STAFF ANALYSIS

CASE NO.:	Z-25-1247529	**File ID #:** 2025-0628
Address:	3265 Northeast Expressway, Chamblee, GA 30341	**Commission District:** 1 **Super District:** 7
Parcel ID(s):	18 267 01 003	
Request:	Rezone property from C-2 (General Commercial) zoning district to HR-1 (High Density Residential-1) zoning district to allow single-family attached, and multi- family developments.	
Property Owner(s):	Reality Income Corporation	
Applicant/Agent:	LMPSF acquisitions, LLC. c/o Troutman Pepper Locke, LLP	
Acreage:	36.46 acres	
Surrounding Properties:	**North:** OI (Office Institutional) **East:** OI **South:** MR-2 (Medium Density Residential - 1), R-100 (Residential Medium Lot-100) **West:** C-2 (General Commercial).	
Comprehensive Plan:	RC (Regional Center) **Consistent x** **Inconsistent**

Site Plan Review (*Illustrative Site Plan - Everstead at Embry Hills, dated 10/17/25*):

PAINT COLOR SCHEME D
UNIT TYPE 312

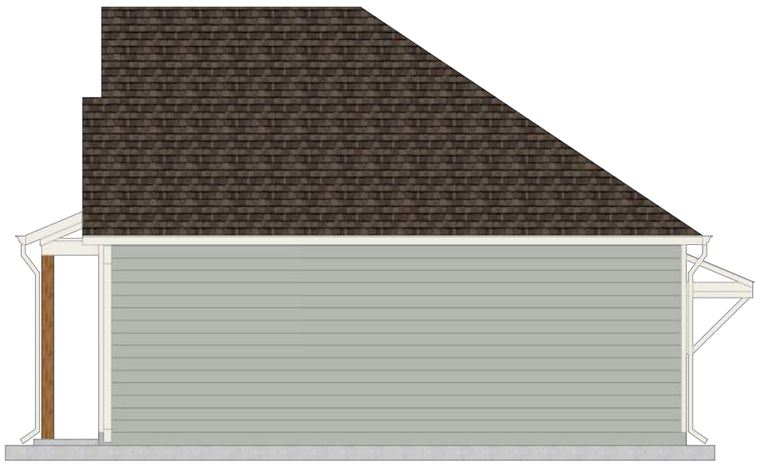
- **Architecture & Design:** To better complement the natural landscape and the housing redevelopment directly north of the site, Staff recommends a combination of ***Scheme D*** and ***Scheme E*** (enclosed) from the provided BTR Color Scheme Elevations. In addition, incorporating red-toned rick into portions of the facade, similar to that found on many of the surrounding ranch-style homes, would further reinforce consistency with the area's established development pattern and character.
